**LOT 1 INDIAN MEADOWS
PHASE I DEVELOPMENT PLAN**

**LOT 1, INDIAN MEADOWS FILING NO. 3
STEAMBOAT SPRINGS, CO 80487**

SITE PLAN

DRAWING: SHEET NO. **C3.1**

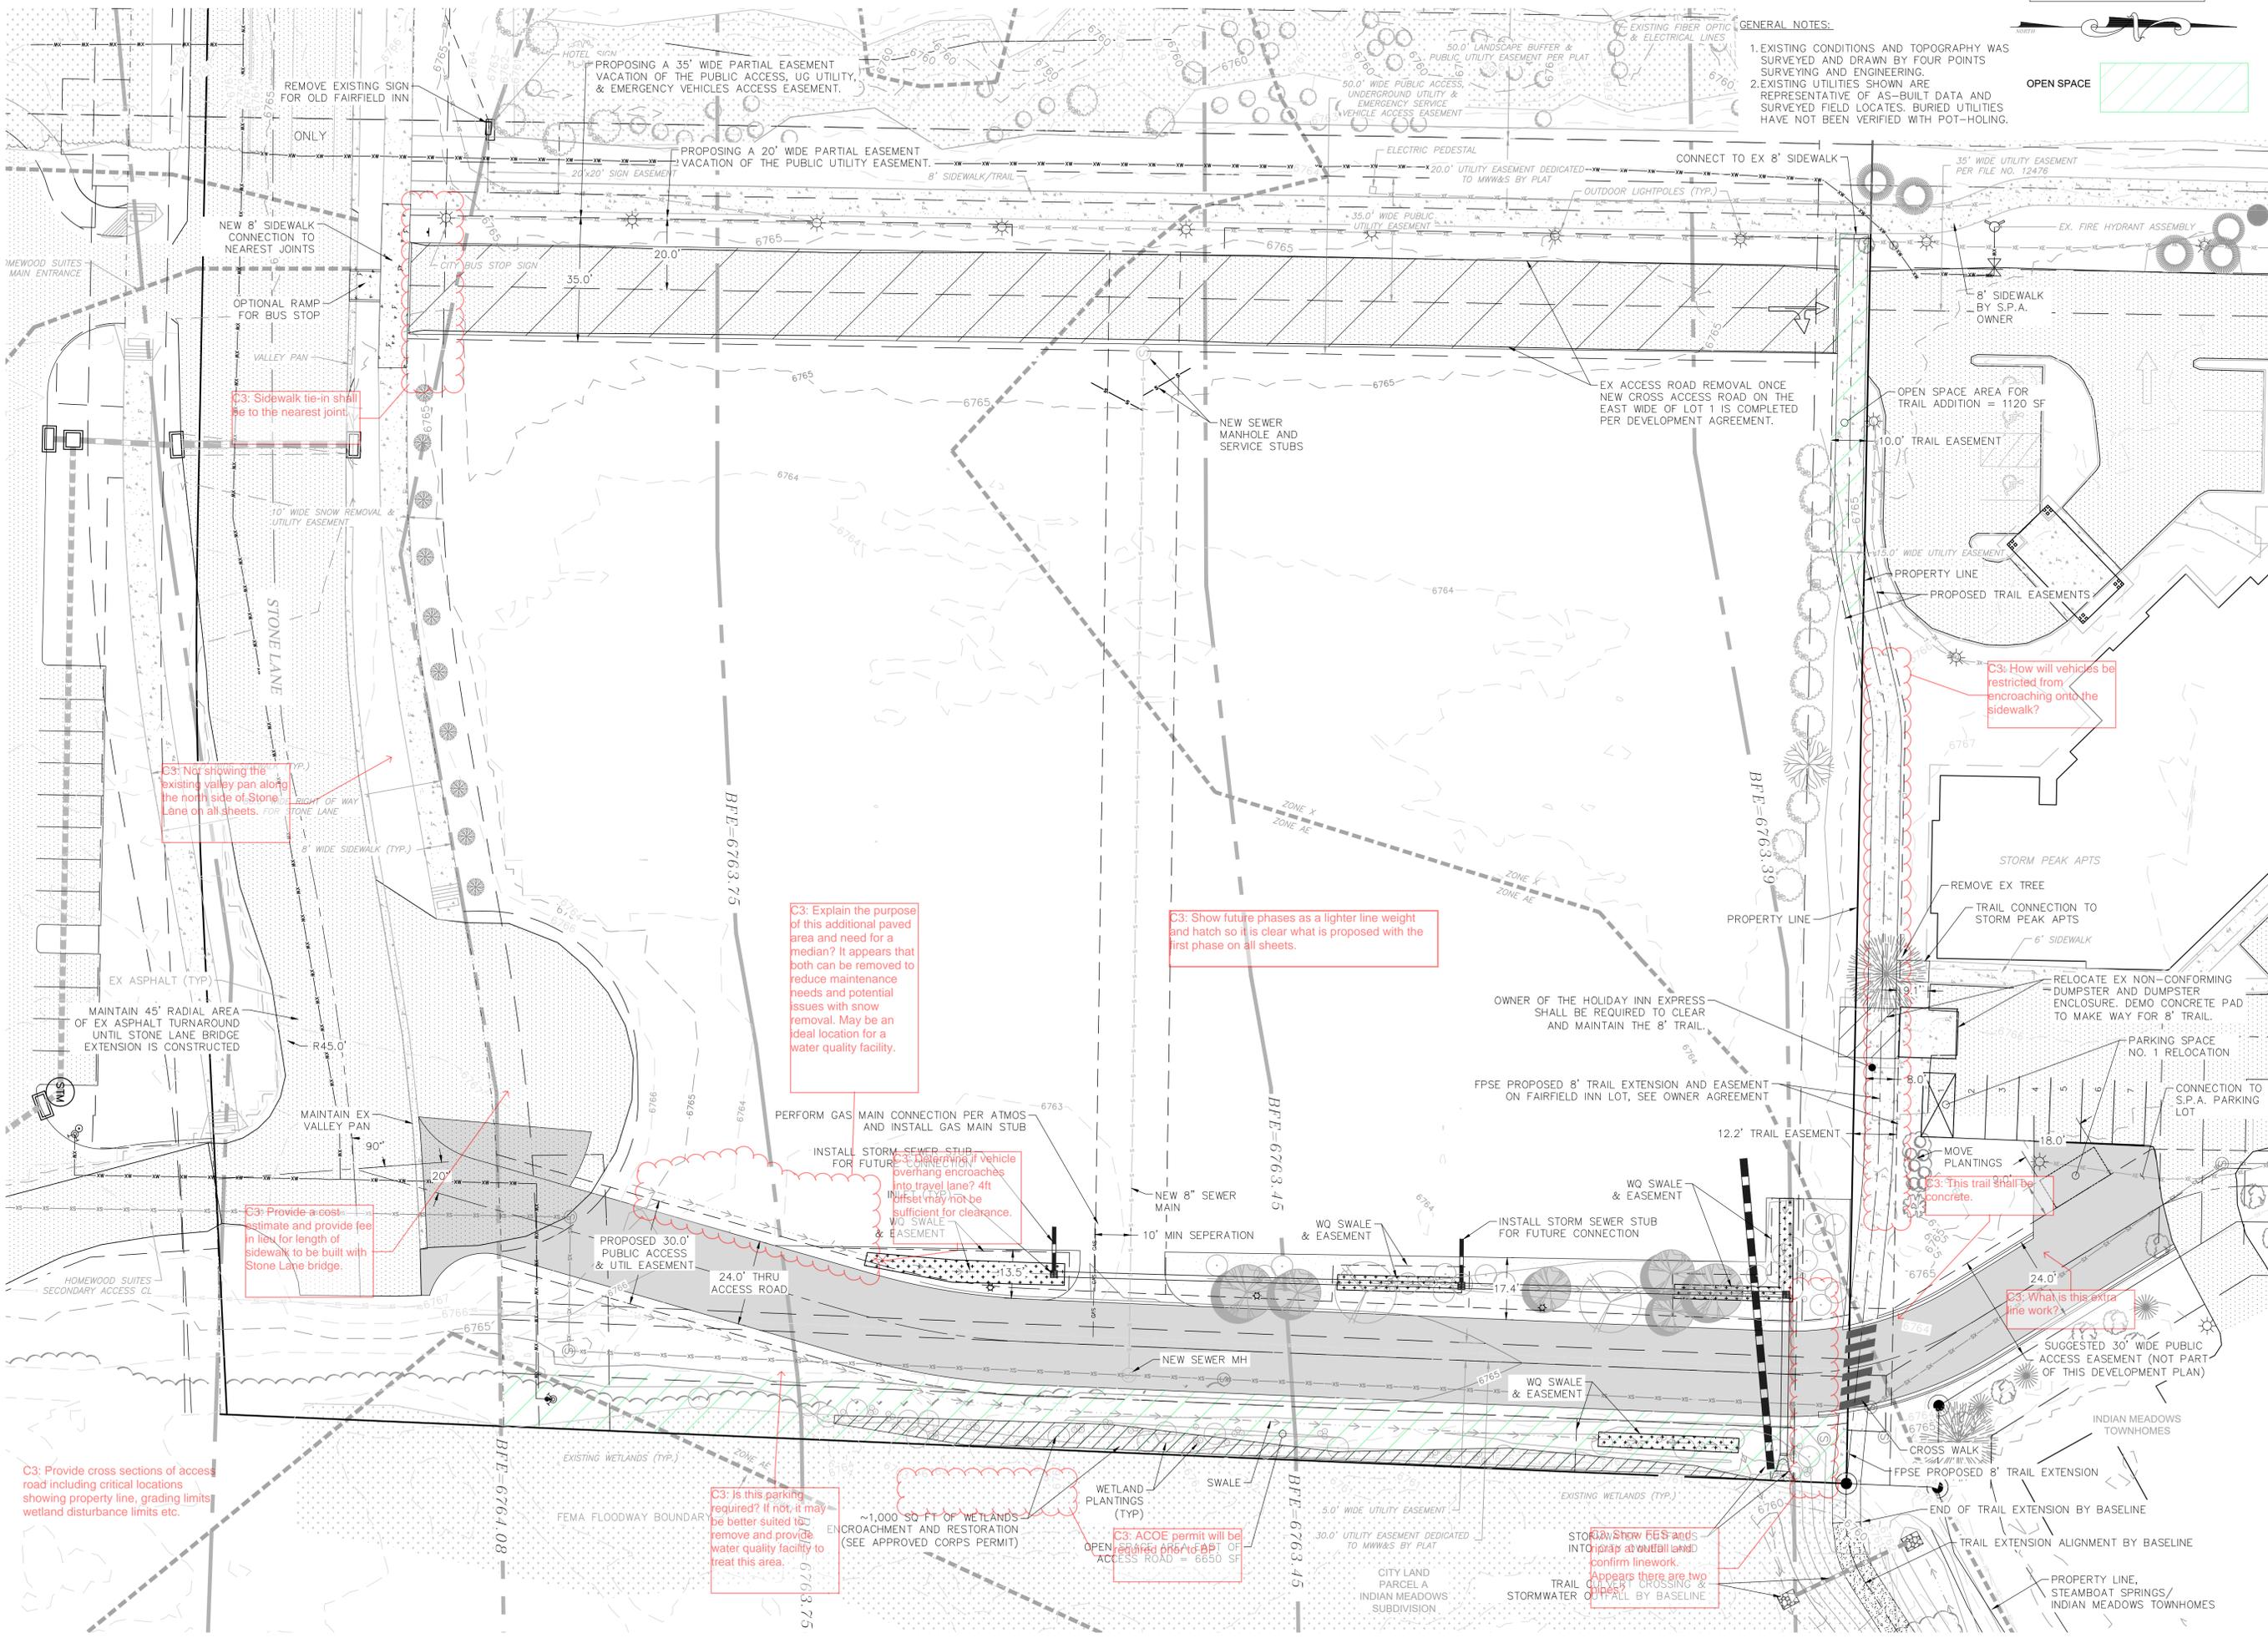
C3: Sidewalk tie-in shall tie to the nearest joint.

C3: Not showing the existing valley pan along the north side of Stone Lane on all sheets.

C3: Explain the purpose of this additional paved area and need for a median? It appears that both can be removed to reduce maintenance needs and potential issues with snow removal. May be an ideal location for a water quality facility.

C3: Show future phases as a lighter line weight and hatch so it is clear what is proposed with the first phase on all sheets.

C3: How will vehicles be restricted from encroaching onto the sidewalk?

C3: Provide a cost estimate and provide fee in lieu for length of sidewalk to be built with Stone Lane bridge.

C3: Clarify if vehicle overhang encroaches into travel lane? 4ft offset may not be sufficient for clearance.

C3: This trail shall be concrete.

C3: What is this extra line work?

C3: Provide cross sections of access road including critical locations showing property line, grading limits wetland disturbance limits etc.

C3: Is this parking required? If not, it may be better suited to remove and provide water quality facility to treat this area.

C3: ACOE permit will be required for 100' of access road = 6650 SF

C3: Show EIS and riparian crossing & confirm line work. Appears there are two lines?
